Application for Works Approval

Works Approval Number W6653/2022/1

Premises Mesa J Hub – TSF8
Mining Lease AML248SA
FORTESCUE WA 6716
As defined by the premises map attached to the issued works approval

Date of report 11 August 2022

Figure 4: Dividing embankment centreline raises

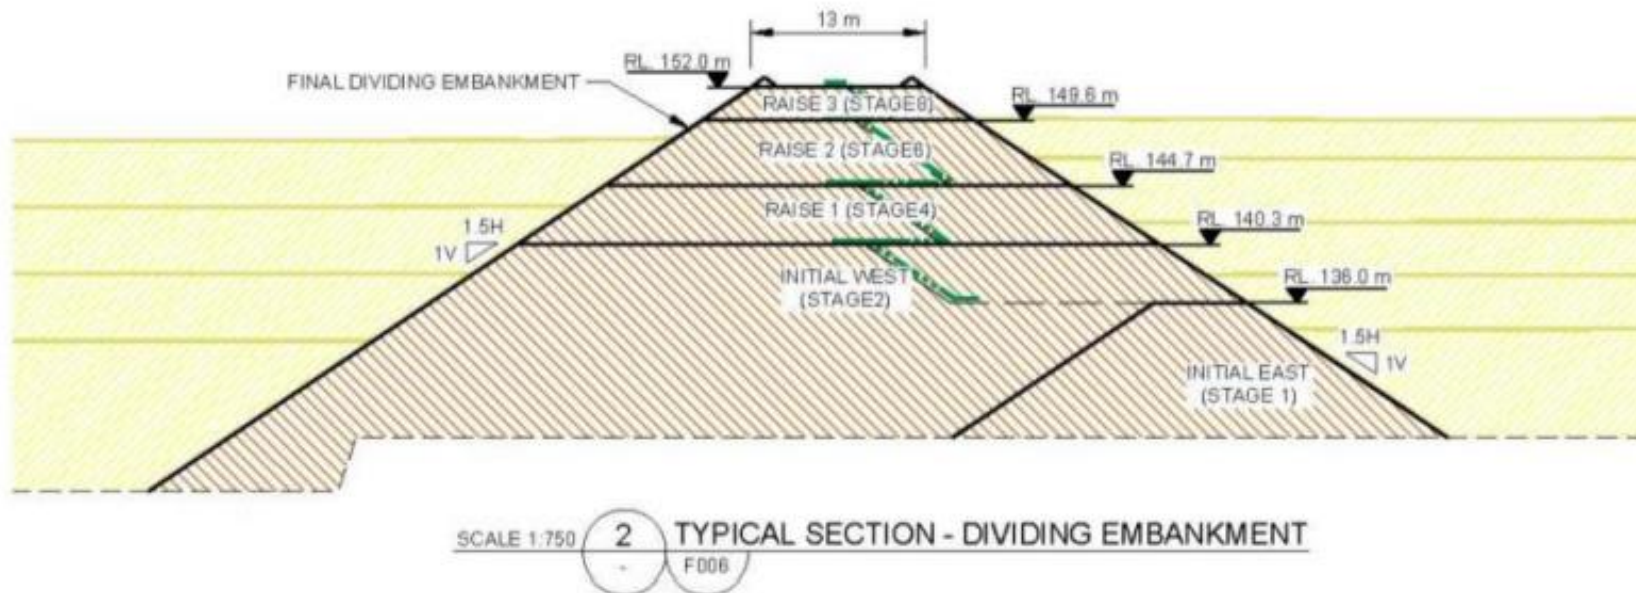
- *The two cells (east cell and west cell) of TSF8 will have a north-south aligned dividing embankment which will initially be constructed to RL 136.0 m. The dividing embankment will be raised incrementally to RL 152 m. Figure 22 of the design report shows that the dividing embankment will be substantially widened (almost three times initial base width) to the west as part of the first raise to RL 140.3 m. This is to prevent the subsequent embankment raise construction on wet tailings or in water.*

- *The stability of the dividing embankment, except the Stage 1 (initial) dividing embankment to RL 136.0 m, has also been analysed and the results meet the ANCOLD recommended requirements. There will be no water against the Stage 1 dividing embankment. Water comes in contact only at the end of Stage 2. Hence, the stability of the dividing embankment will not be a concern during Stage 1 and until the end Stage 2 operation.*
